SERVICE BULLETIN Nr 53

SUBJECT : Removal of the 40 A fuse located near the engine (50 A on HR 100/120)

AIRCRAFT CONCERNED : HR 100/210 all types : up to n° 205 inclusive
 DR 400 all types : up to n° 987 inclusive
 except. n° 976 - 980
 HR 200 all types : up to n° 49 inclusive

Date : Sept. 3 rd 1974

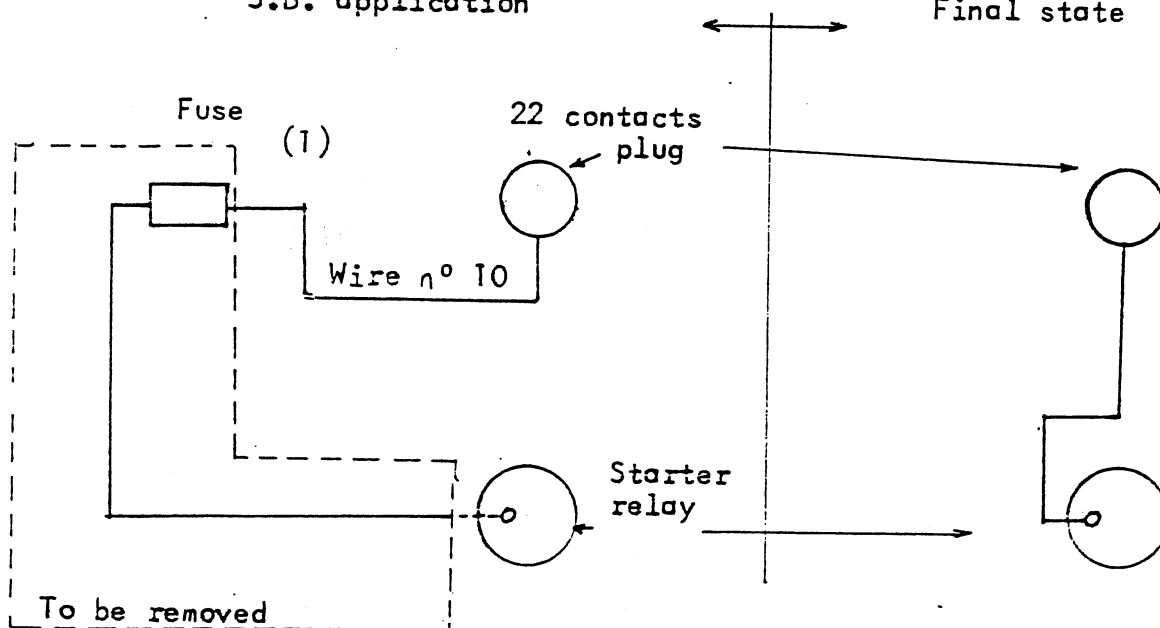
The reliability of the battery 40 A fuse (50 A on HR 100/210) located near the engine mount being not very good we recommend to remove this fuse and its protecting box. The purpose of this fuse was to protect the electrical circuit during ground maintenance. This protection will be now realised by de-connecting the battery before any maintenance operation on the electrical circuit.

After removal of the fuse and its box connect directly the electric wire n° 10 between the 22 contacts plug located on firewall and the starter relay.

S.B. application

Final state

(1) Place an AMP yellow Ø8 terminal ref. 35111
